Storage Bridge Bay (SBB) Specification 1.0 Errata

Revision A

September 21, 2006

This document contains errata to SBB Specification Version 1.0. It is the intention of the SBB Working Group to incorporate the errata in the next revision of the SBB specification.

Figure 1: Air Inlet and SBBMI Module Locations

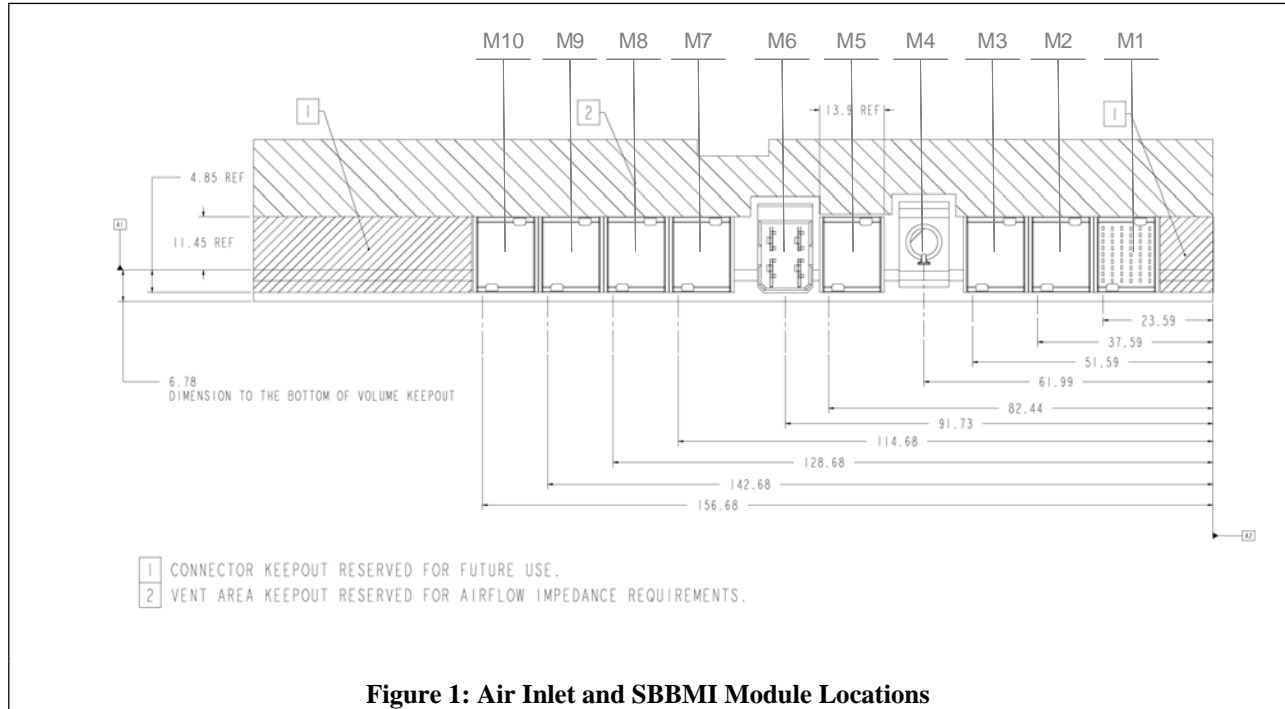
The dimensions listed in Figure 7 for some of the signal module locations are incorrect. Figure 7 will be replaced with the following figure that contains the correct dimensions:
